工程指示 / 要求簡箋 ENGINEER INSTRUCTIONS(E.I.)

工程指示編號:	EI- 5324	修改版本:	-
	HK- 1981		
工程編號:	J 852	工程名稱:	亞皆老街中電
收件人:	生統	發件人:	Lai Sik Hung
工程項目:	T1 -T3 牆身隔音板底收口鋁板 生產 (急)	日期:	11/11/2022

內容: T1 -T3 牆身隔音板底收口鋁板 生產 (急)

From: midiaqs@midiltd.com.hk <midiaqs@midiltd.com.hk>  
 To: jimmyhcheung@sino.com, stephenchow@sino.com  
 Subject: CLP - Acoustic Fins 底部加做 3mm 厚收口鋁板(Matching Color)  
 Date sent: Thu, 03 Nov 2022 17:06:16 +0800  
 Copies to: deltasung@midiltd.com.hk <deltasung@midiltd.com.hk>, midiaqs@midiltd.com.hk <midiaqs@...

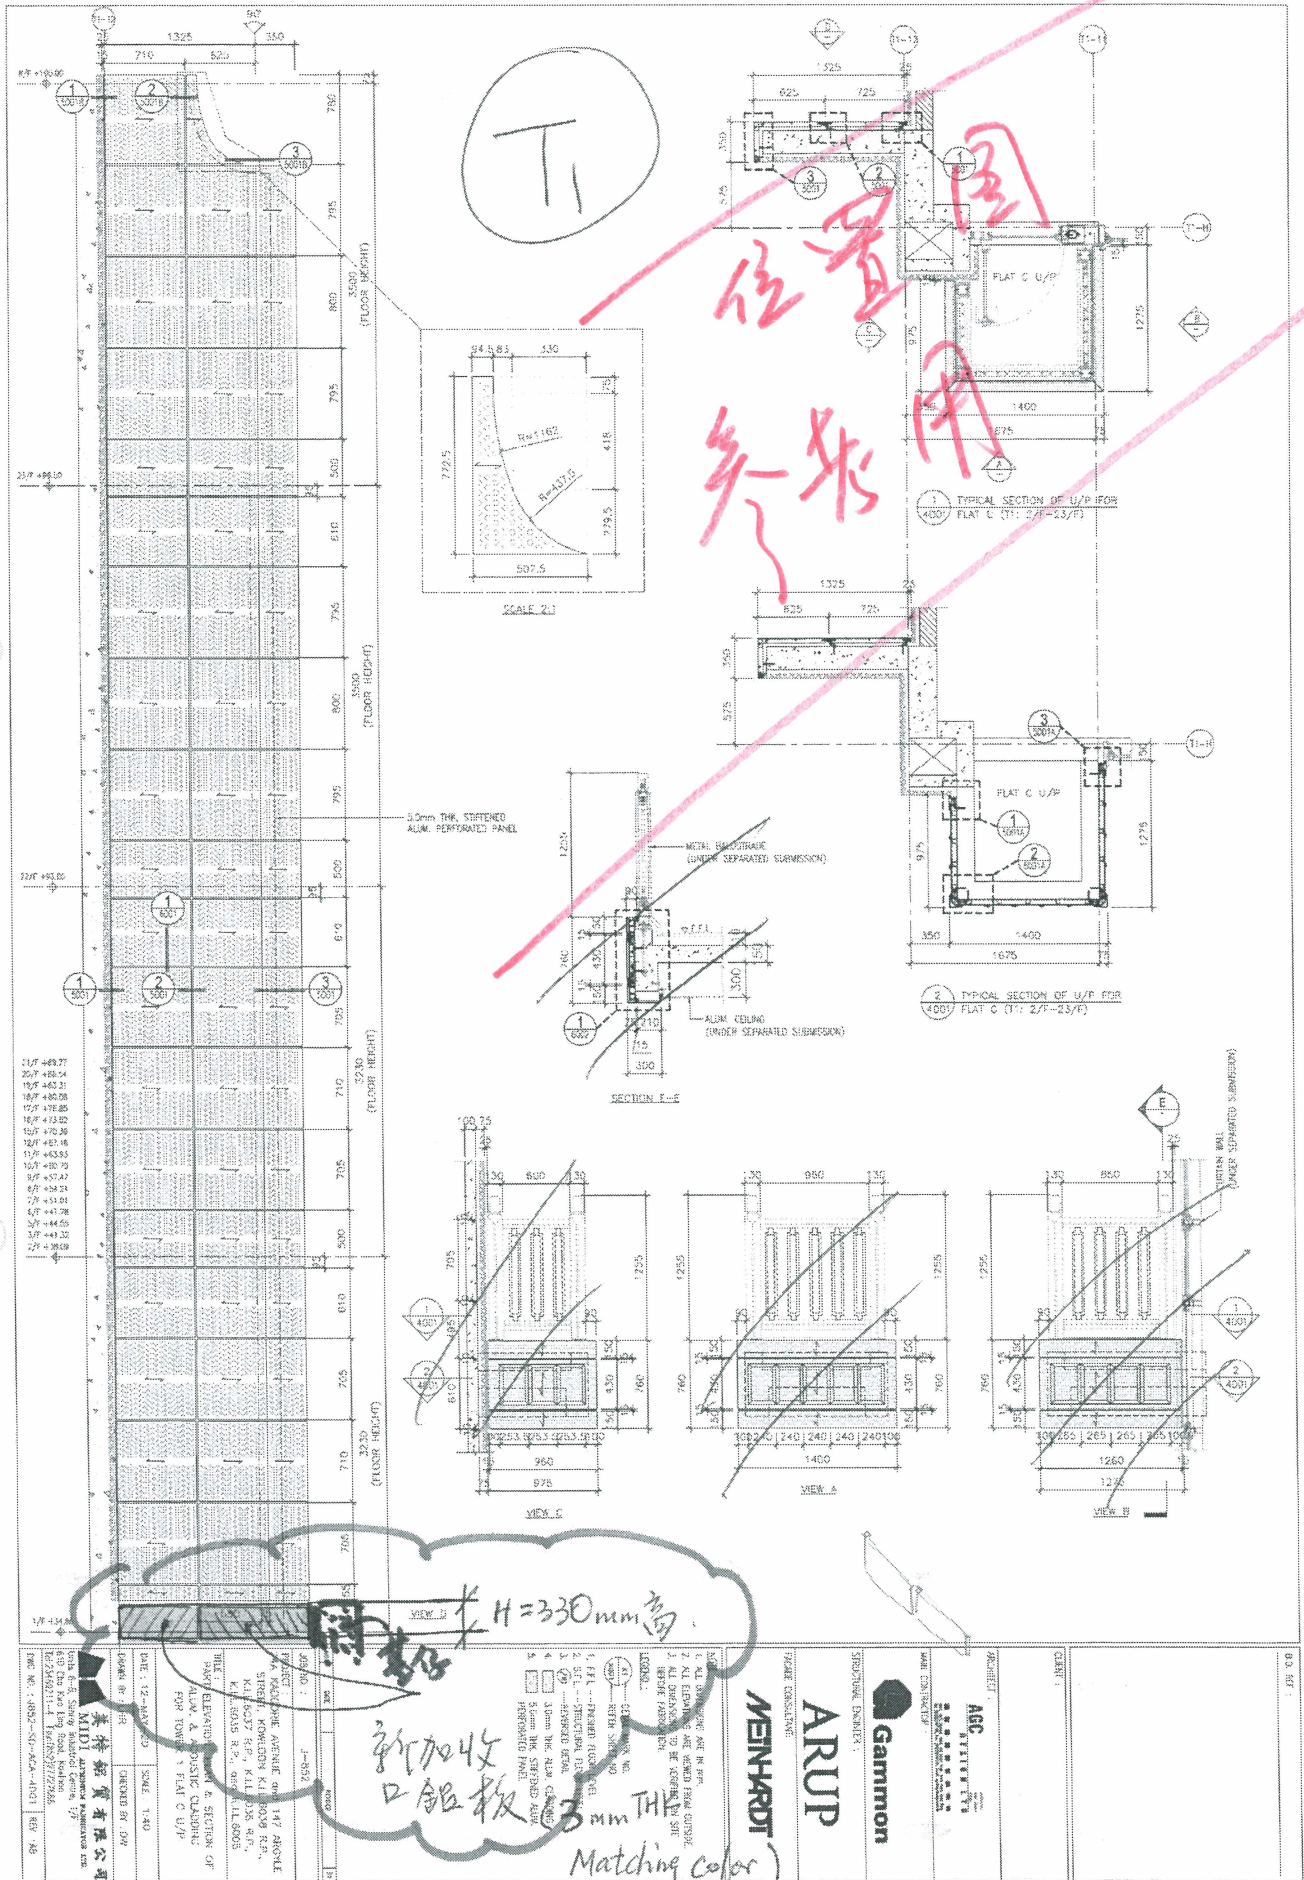
附件是 Acoustic Fins (T1, T2 and T3) 底部加做 3mm 厚收口鋁板 (顏色參照原有孔板)的示意圖，閣下及 Stephen 於今天已確認做法，我司將按此備料及加工，請發出 SI 作記錄。謝謝!

附件是 Acoustic Fins (T1, T2 and T3) 底部加做收口孔板的示意圖，請看看確認做法及請發出 SI。謝謝!

SK-2

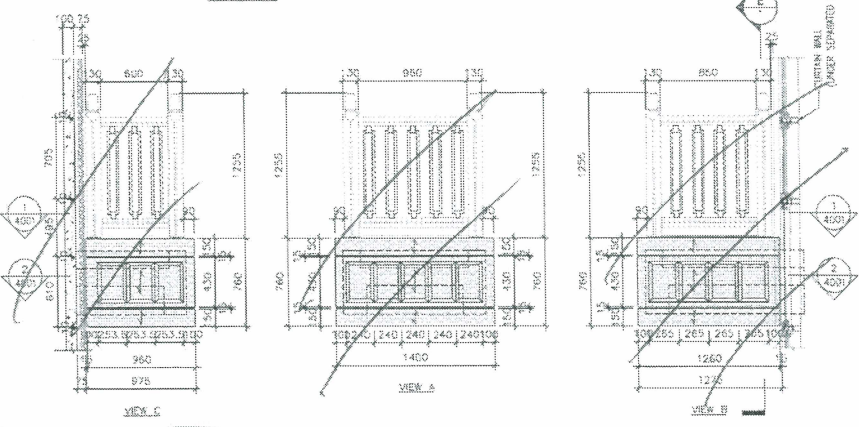
H=330mm高

新加坡  
口銀板  
3mm THK  
Matching color

CASE A

SK-4

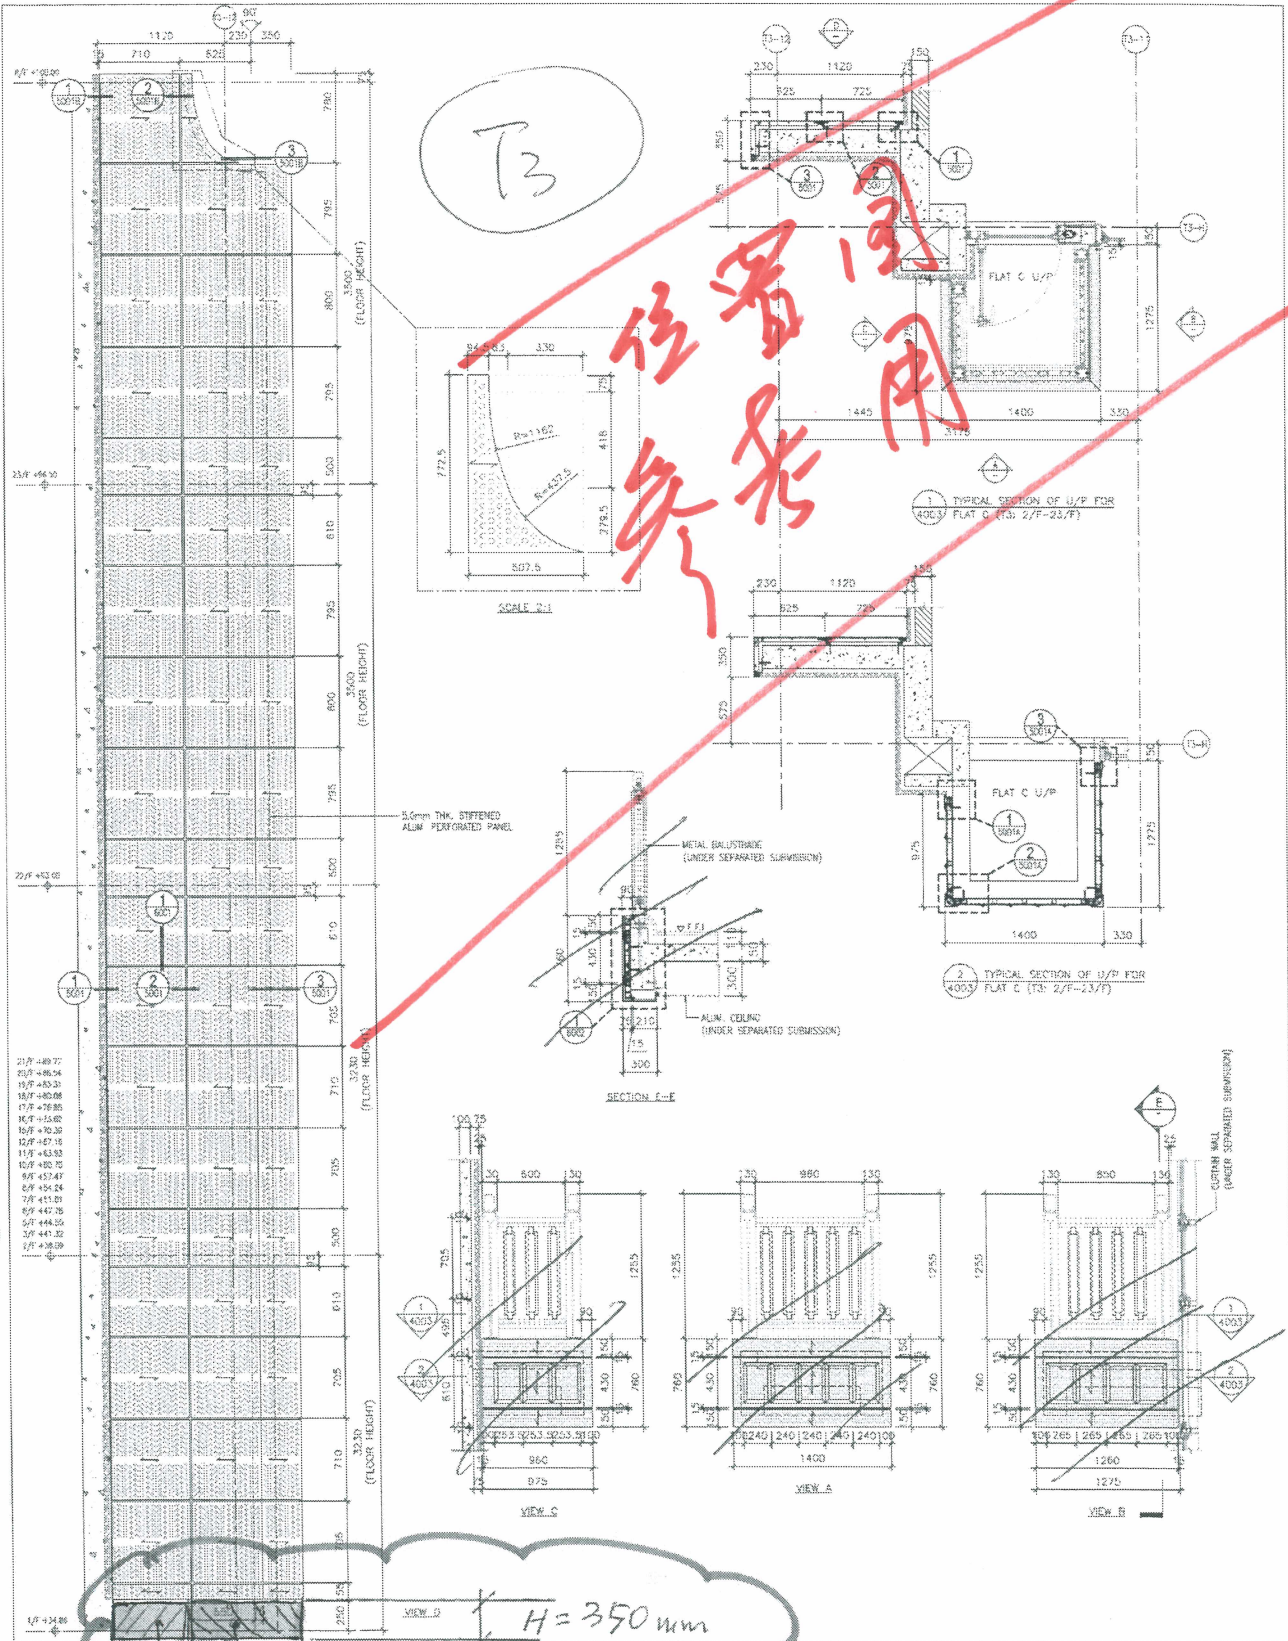
位置同  
原图

新加坡  
D 铝板  
3mm THK  
Matching color

CASE B

CASE A - for T1 & T2

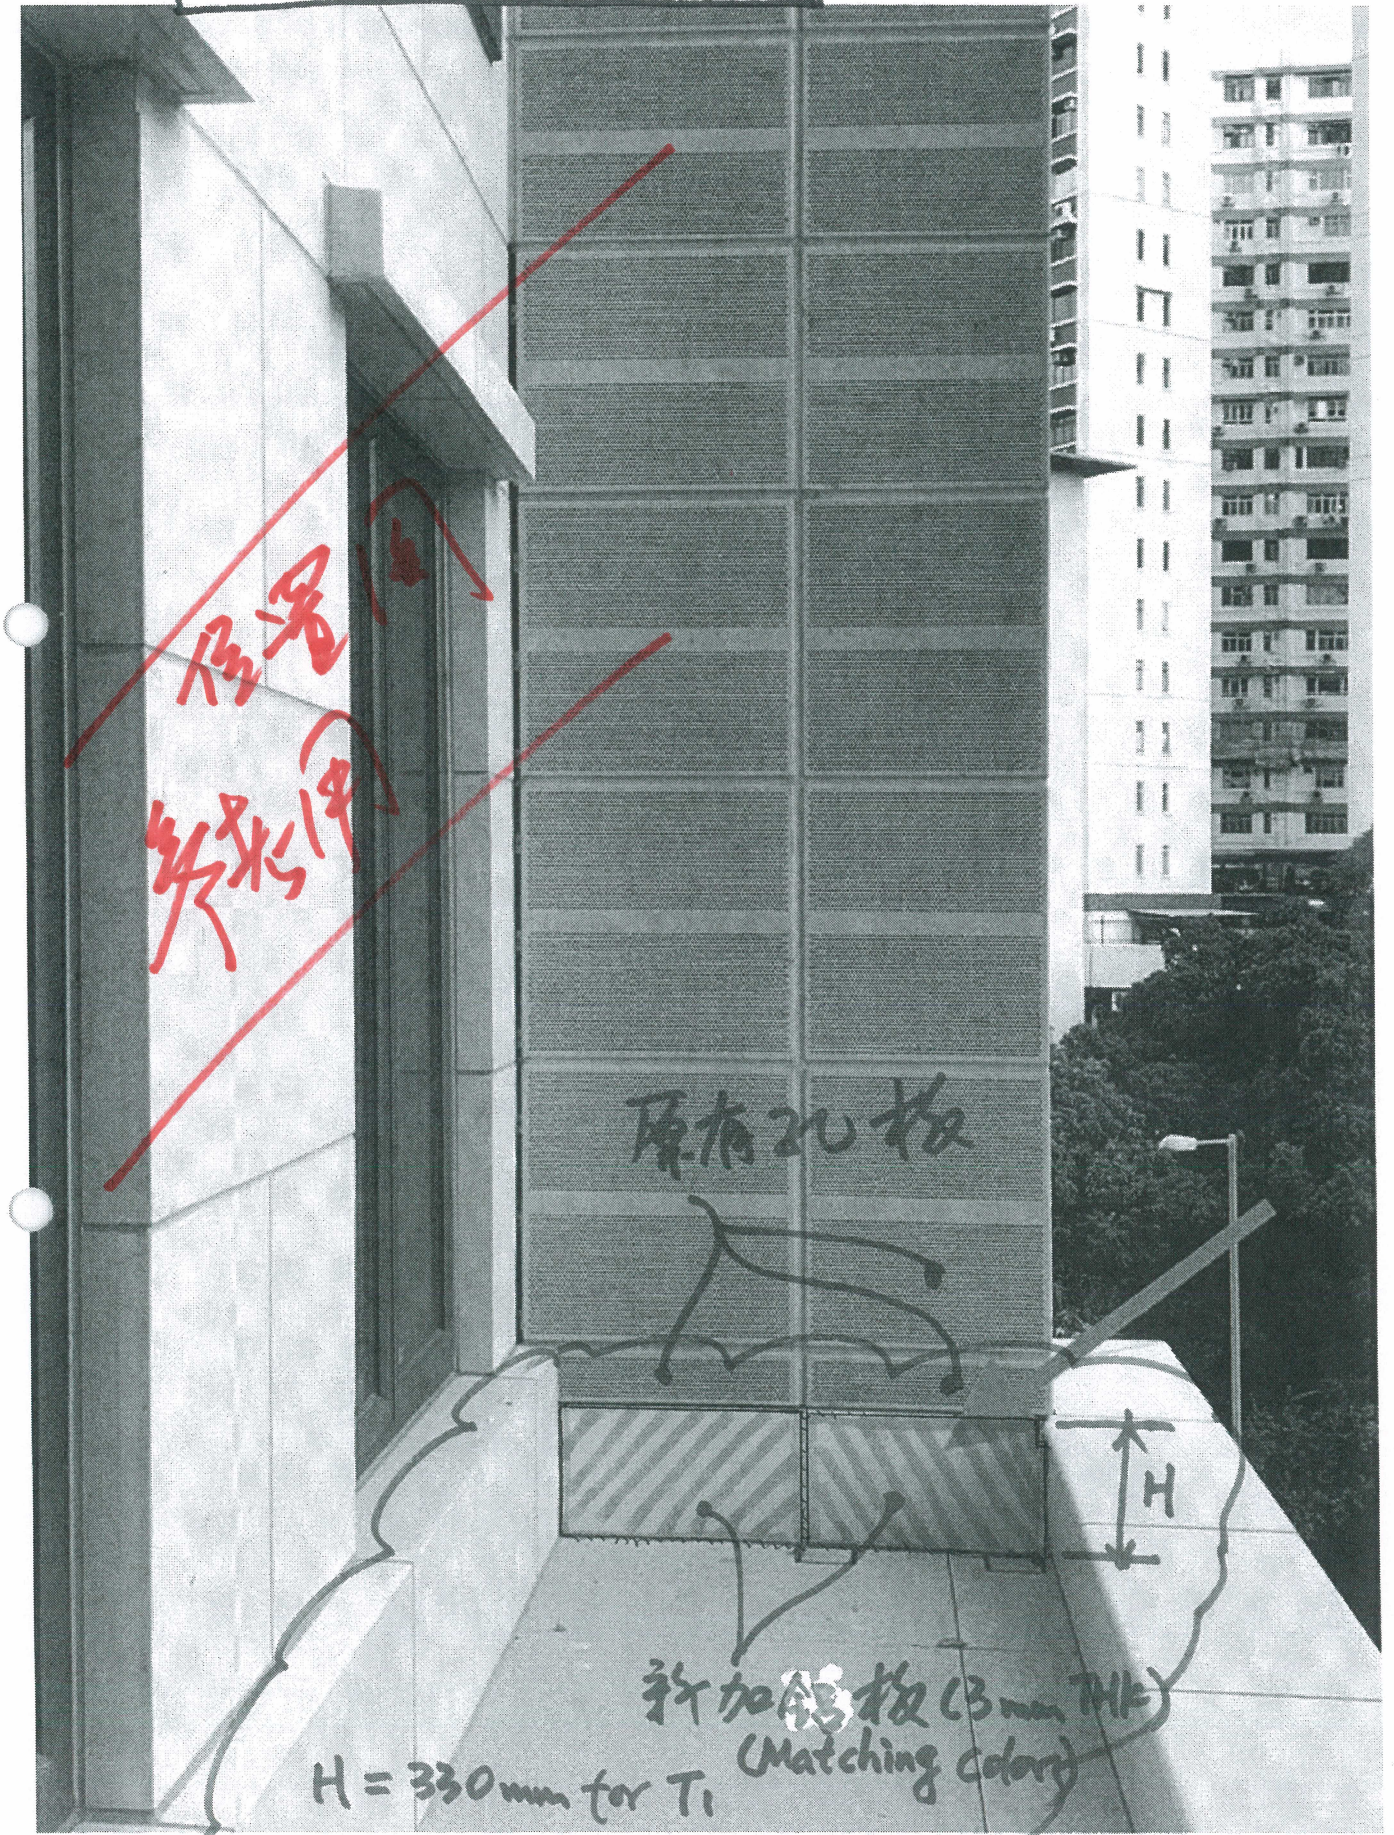
原有20板  
新加铝板

新加铝板 (3mm THK)  
(Matching Color)

H = 330mm for T1

H = 365mm for T2

现场量  
18云石

新加铝板 2 件 (铝座)  
(3mm THK)  
(Matching color)

CASE B - for T3
